680/682 Synergy Indicator

Configuring Second Generation CPU Boards

Figure 1. Revision Sticker Location

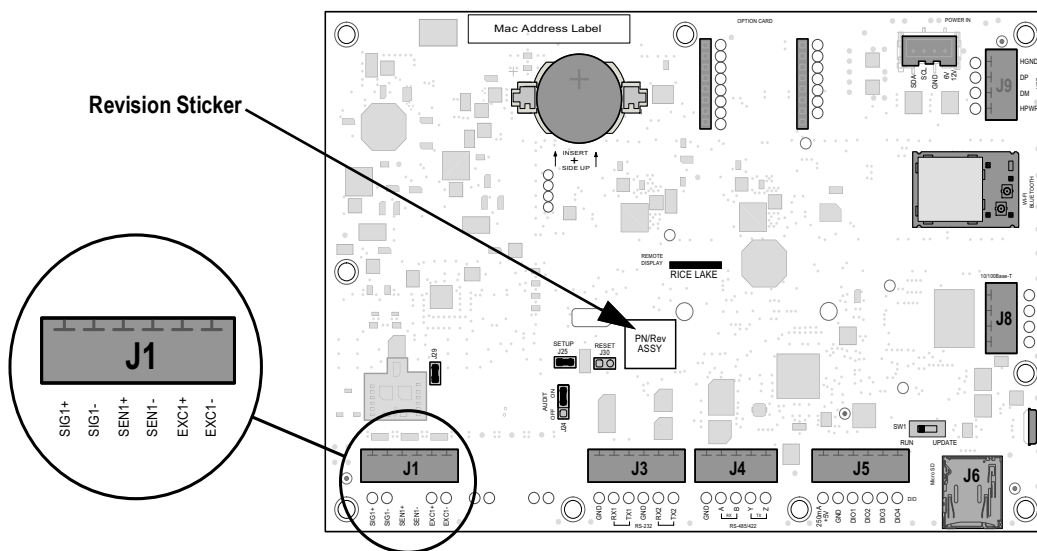
Issue: The scale will not display weight due to reference error with 4-wire load cell connection

First generation CPU boards have sense switches and are configured through the indicator menu while the second generation does not have sense switches and requires installing jumper wires in 4-wire configuration to avoid errors.

Locate the revision sticker on the CPU board as shown in [Figure 1](#).

Solution: Install jumper wires for 4-wire load cell connection

IMPORTANT: To configure a second generation CPU board for a 4-wire connection, install a jumper wire between EXC+ and SEN+ and another jumper wire between EXC- and SEN-.
